# UNITED STATES PATENT AND TRADEMARK OFFICE

APPLICATION NO.	FILING DATE	FIRST NAMED INVENTOR	ATTORNEY DOCKET NO.	CONFIRMATION NO.
10/596,957	06/30/2006	Norman E. Wandke	US040029US2	8971
24737 7590 08/05/2009 PHILIPS INTELLECTUAL PROPERTY & STANDARDS P.O. BOX 3001 BRIARCLIFF MANOR, NY 10510			EXAMINER THOMAS, COURTNEY D	
			ART UNIT 2882	PAPER NUMBER
			MAIL DATE 08/05/2009	DELIVERY MODE PAPER

<b>Office Action Summary</b>	<b>Application No.</b>	<b>Applicant(s)</b>	
	10/596,957	WANDKE ET AL.	
	<b>Examiner</b>	<b>Art Unit</b>	
	Courtney Thomas	2882

**DETAILED ACTION**

**Figs. 1-3, X-ray tube - U.S. Patent 7,209,546 to Arnold et al.**

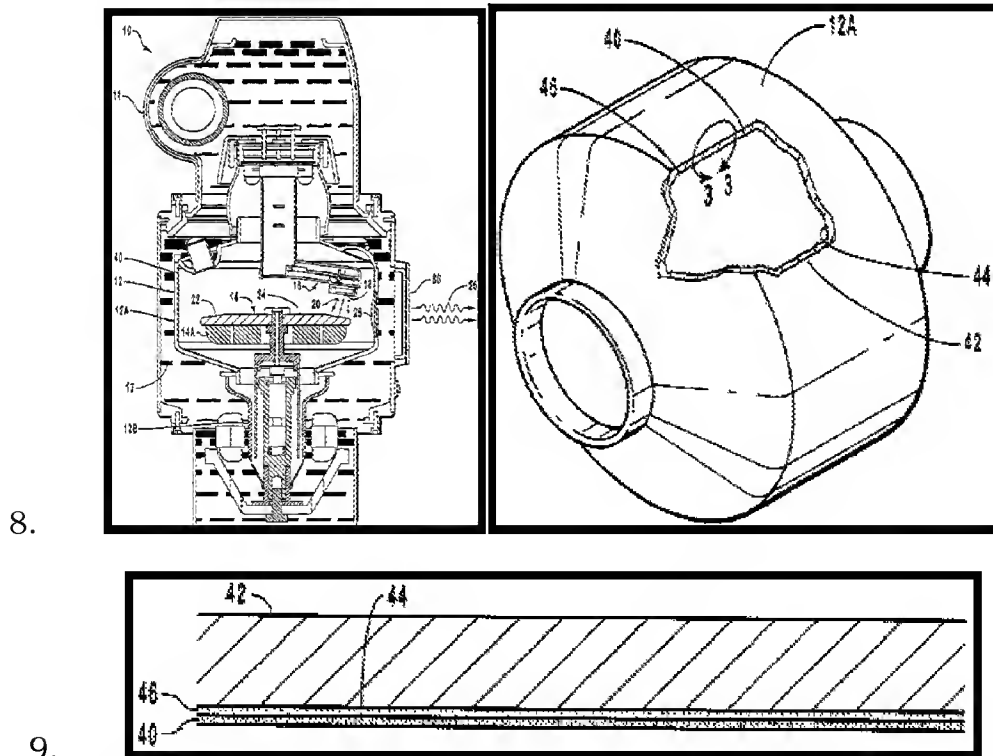
7. Claims 1, 17 18, 20 and 21 are rejected under 35 U.S.C. 102(e) as being anticipated by Arnold et al. (U.S. Patent 7,209,546).

10. **As per claims 1, 17 and 20**, Arnold et al. disclose an X-ray tube (**10**) comprising: an outer housing (**11**) surrounding at least a portion of the X-ray tube and containing a cooling fluid (**17**), a frame (**12**) which encloses an evacuated chamber (col. 6:61-63); an anode (**14**) disposed within the evacuated chamber; the frame (12) including a vessel which surrounds the anode (14), the vessel being defined by a combination of: a material (**42** - see also col. 7:66 - 8:1) with high thermal conductivity and lower deformation resistance (relative to a second) material (**40** - see also col. 8:58-61) with a high deformation resistance and lower thermal conductivity. [Examiner note: material (42) - Cu - Thermal conductivity ~400 W/mK; Yield strength ~ 714 kg/cm<sup>2</sup>; material (40) - Ti/ Titanium alloy(s) - Thermal Conductivity ~22 W/mK; Yield Strength ~ 2800 - 9007 kg/cm<sup>2</sup> (range includes titanium alloy values); For purposes of examination, Examiner equates element (42) as a “thermally conductive liner” and element (40) as a “structural framework” - the noted properties of the elements are considered to provide the functional limitations of the claims (thermal conductivity and deformation resistance)].

11. **As per claims 18 and 21**, Arnold et al. disclose a method comprising the step(s) of: conducting heat away from an evacuated chamber through a liner (42) formed from a thermally conductive material and restraining the liner against deformation with a structural framework (40) - see for example Figs, shown above; see also Examiner note above and respective portions of Arnold et al. (not shown above)).
